ADDENDUM

AD #4

Project **West Point Dairy - Hyrum - Storage Warehouse**
Project No. **250429500**
Location **Hyrum, Utah**
Date **August 21, 2026**

STORAGE WAREHOUSE EXPANSION FOR:
WEST POINT DAIRY PRODUCTS

STRUCTURAL SILO PAD DETAILS

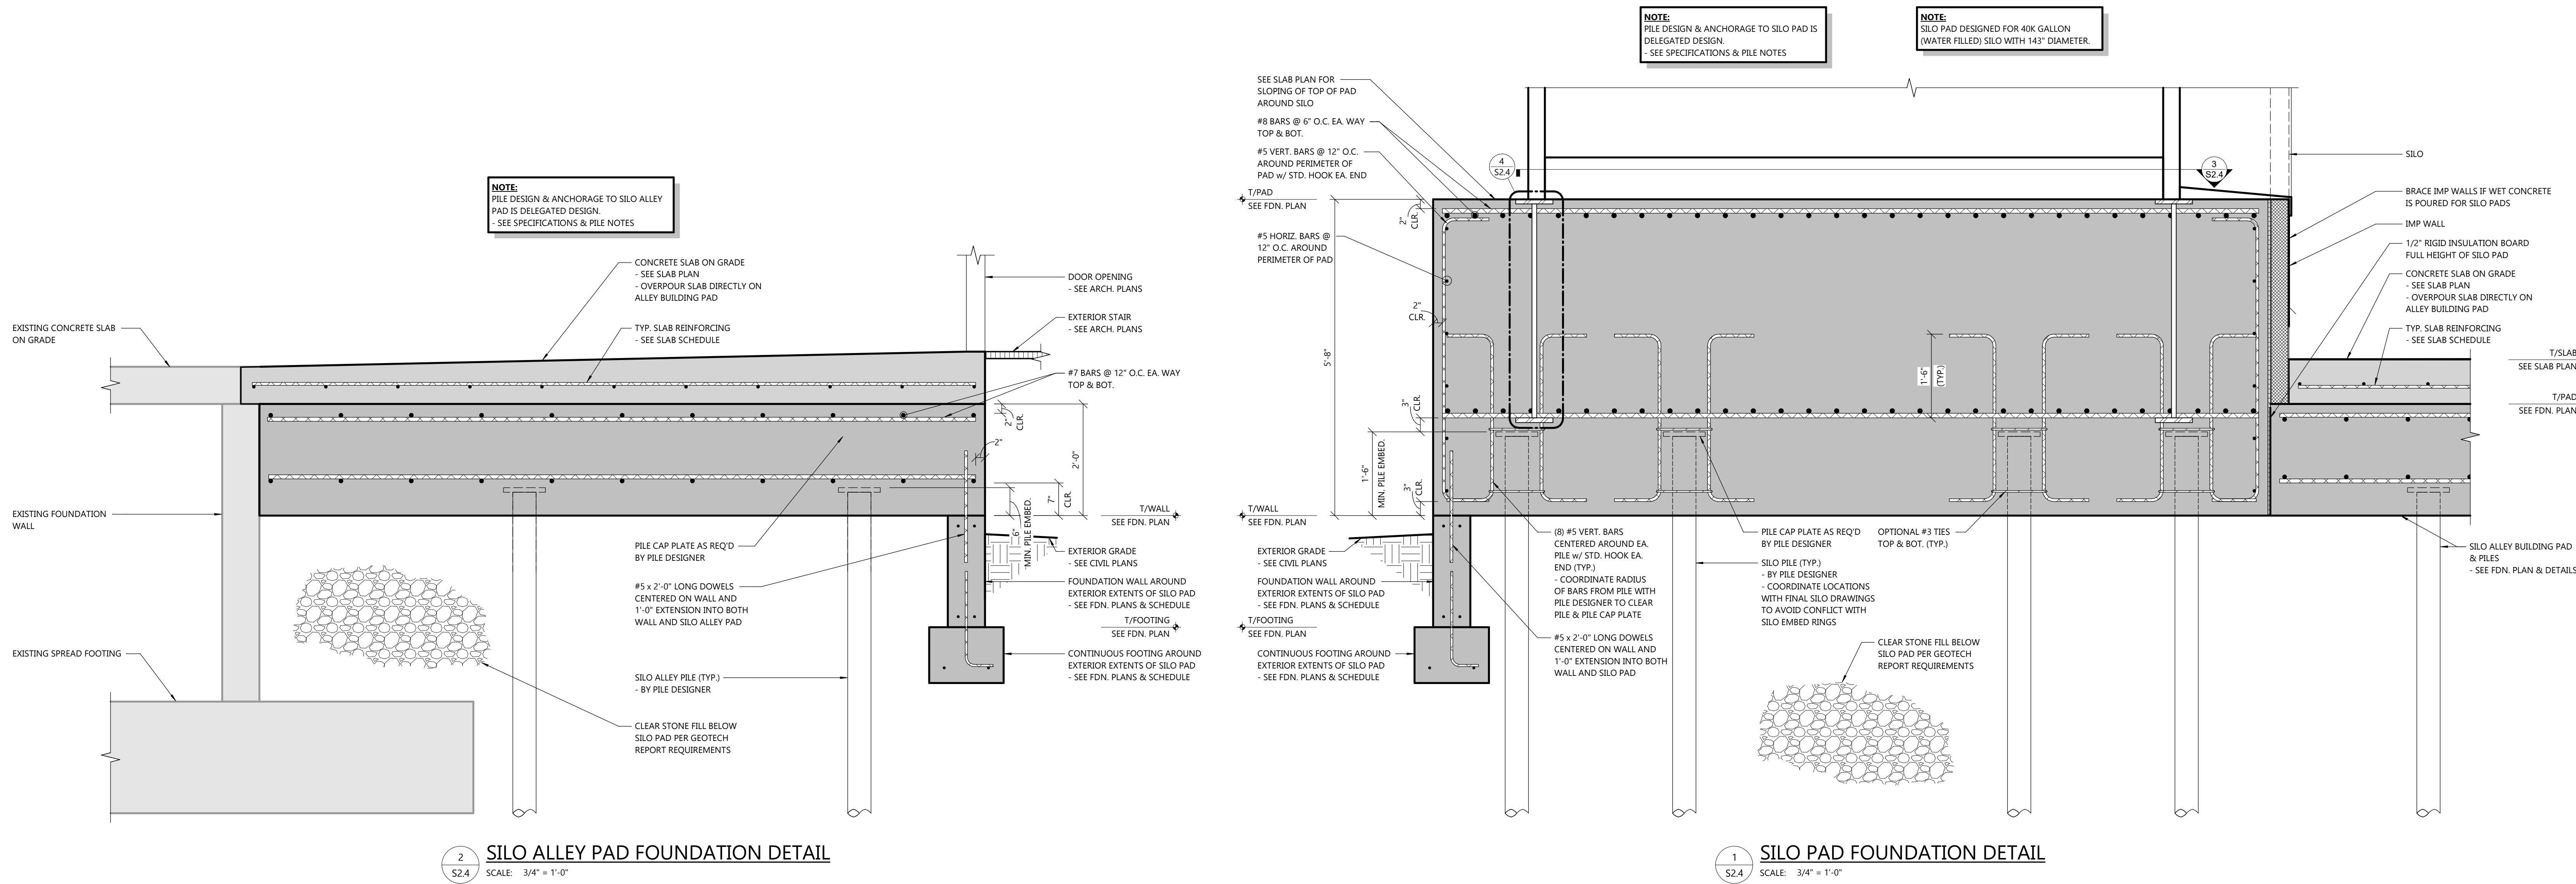
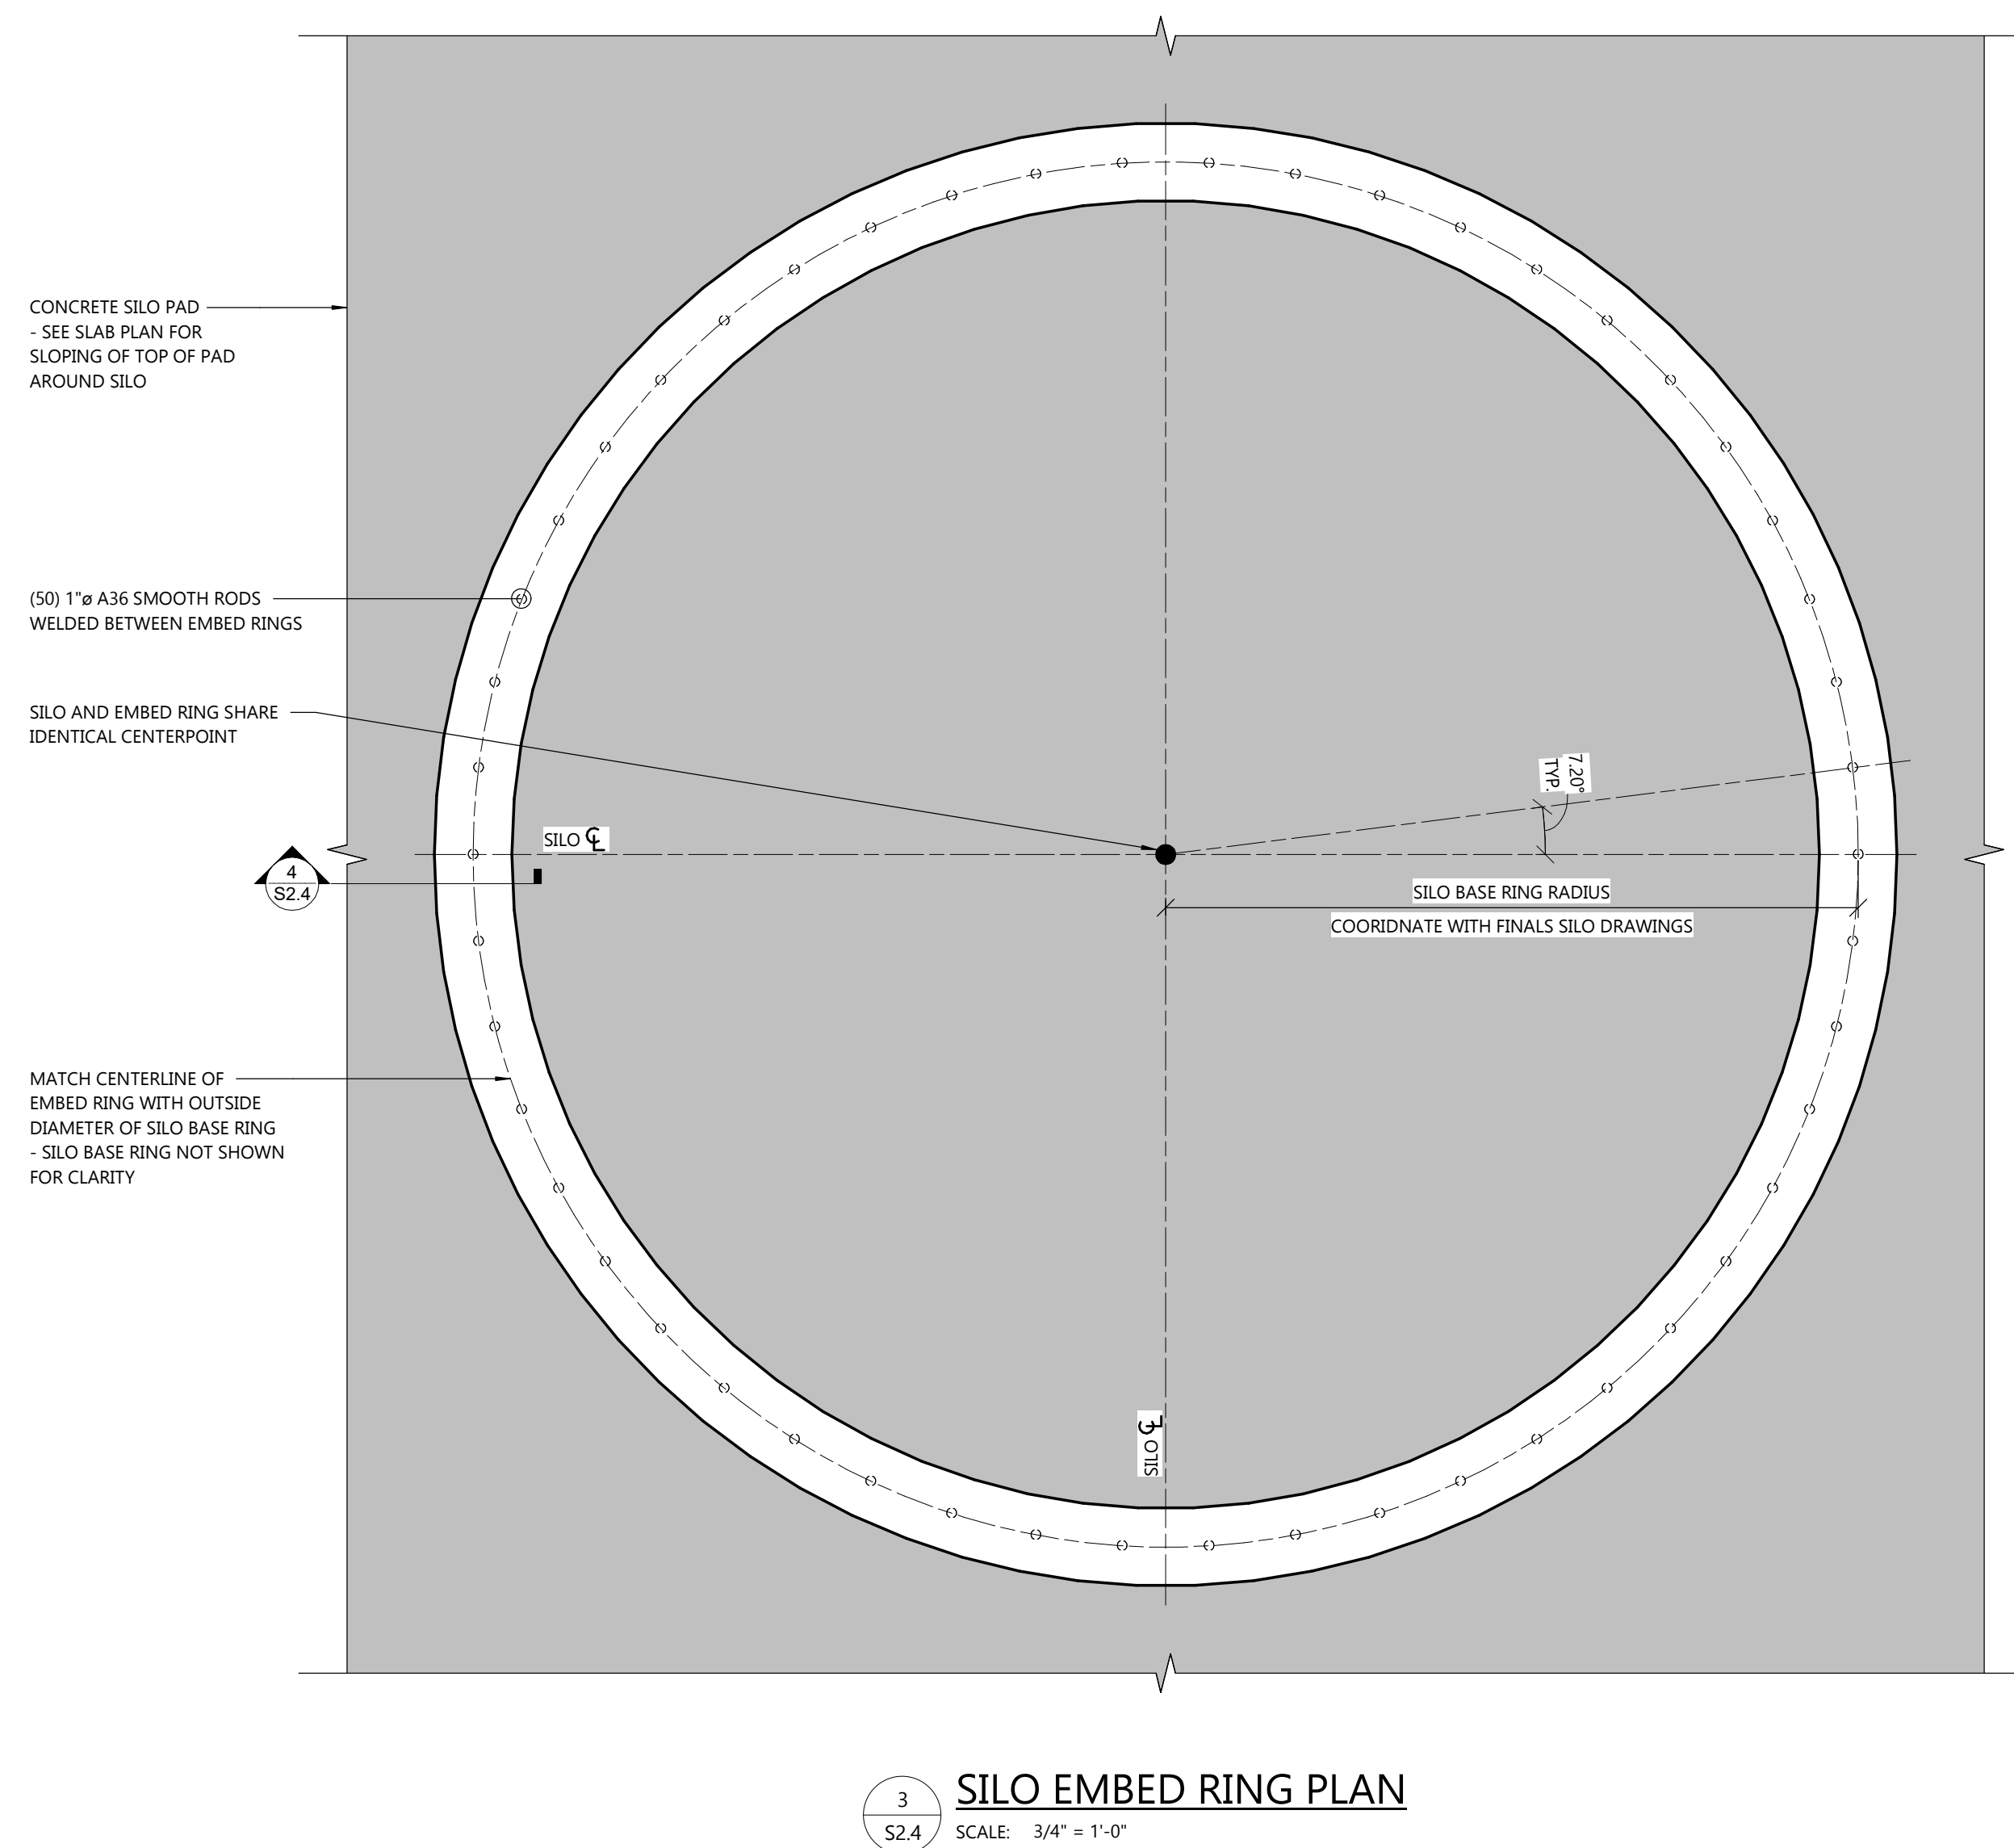
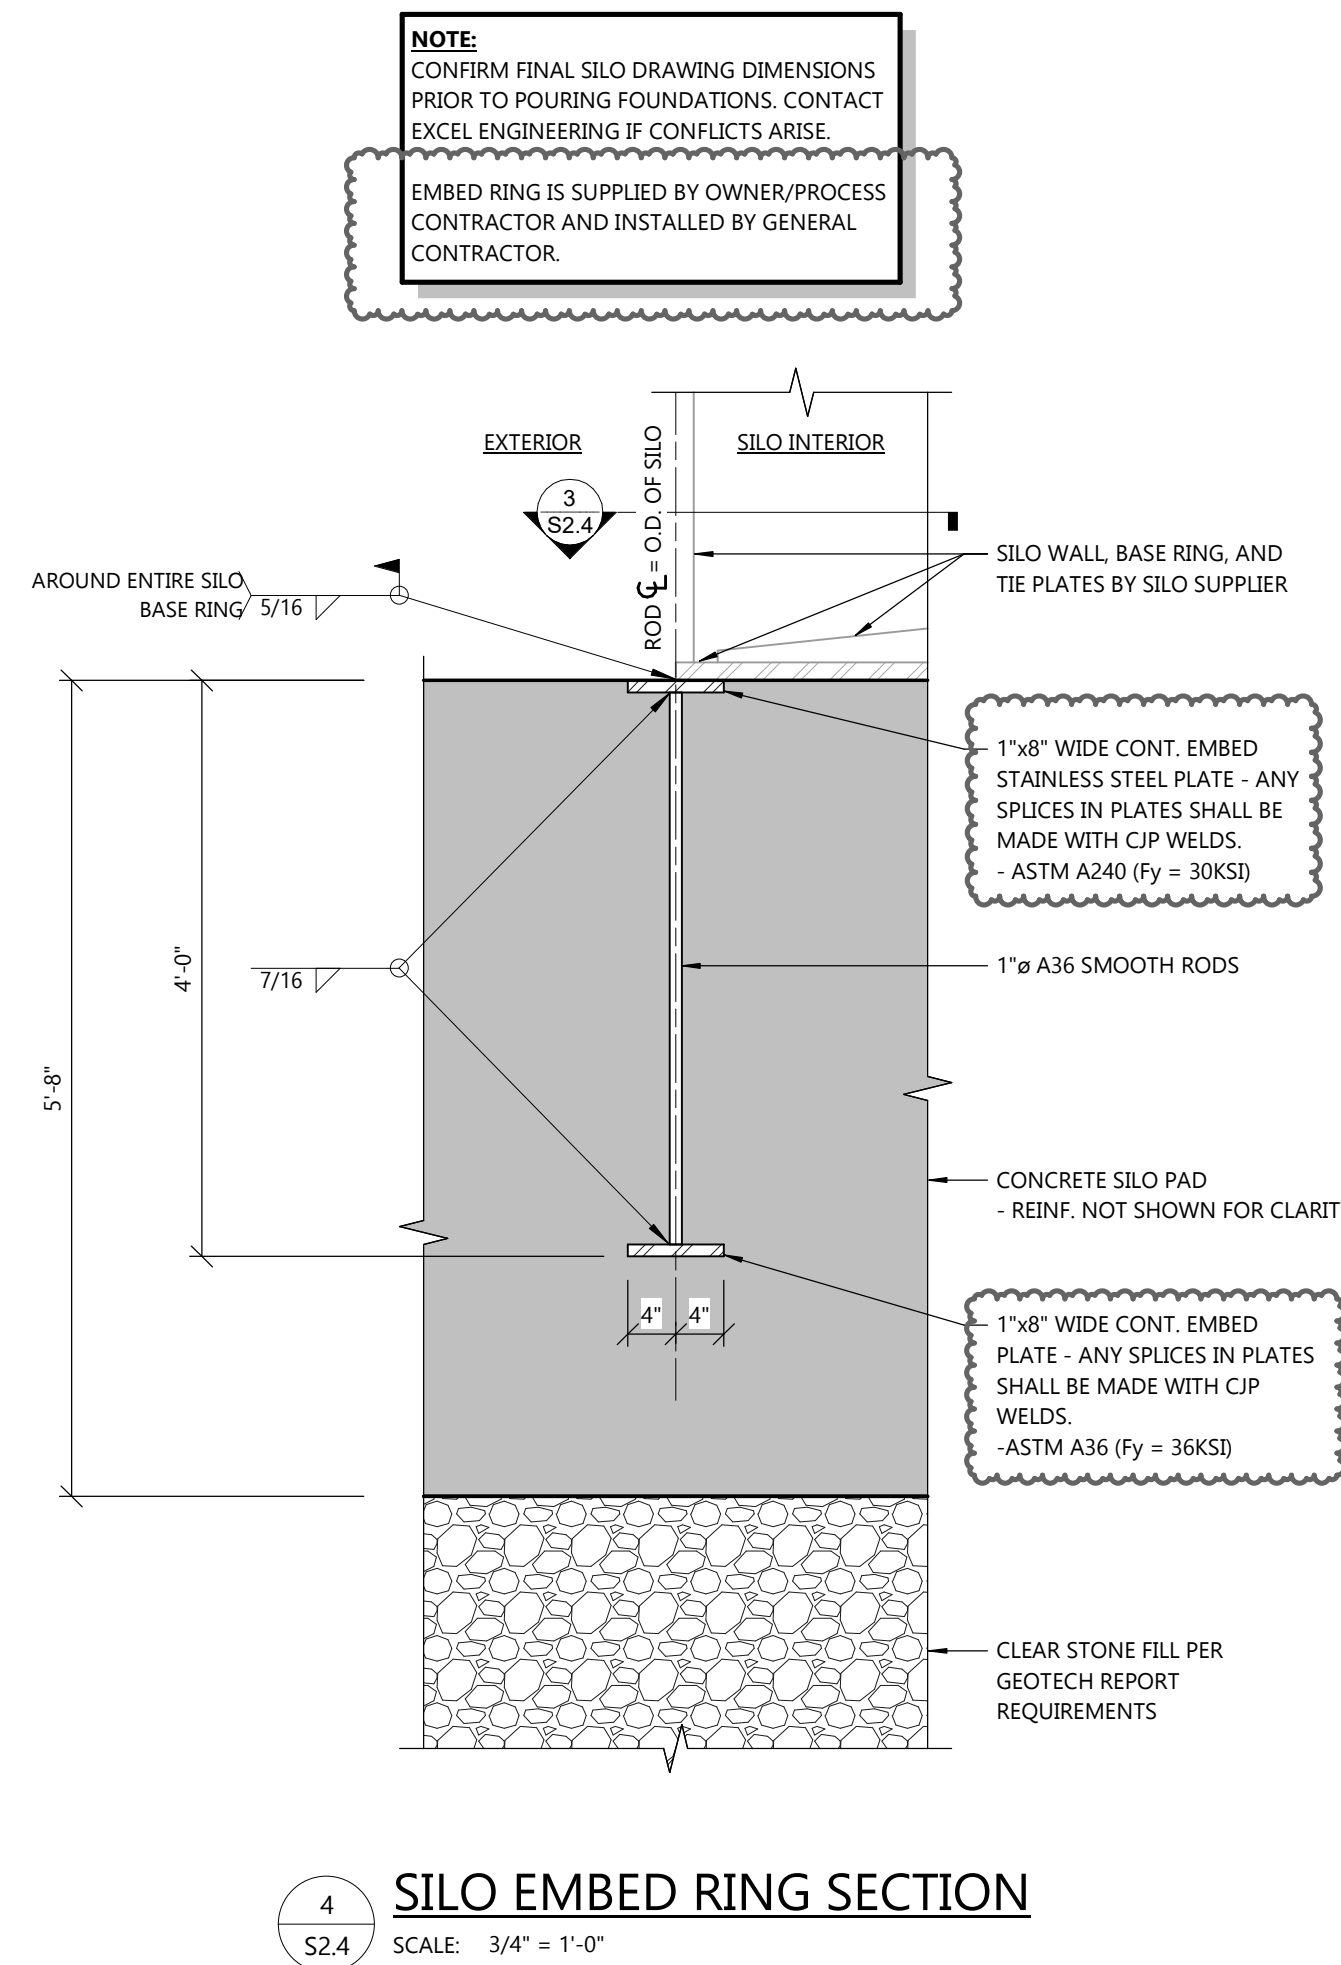
T1.0	Updated sheet index.
T1.1	Updated future project footprints.
	Updated Square footages.
T1.1PH	Updated Sheet.
A1.0	Updated future project footprints
S2.4	Updated top plate of silo embed ring to stainless steel
E1.1AL	Added circuit tags to emergency exit signs.
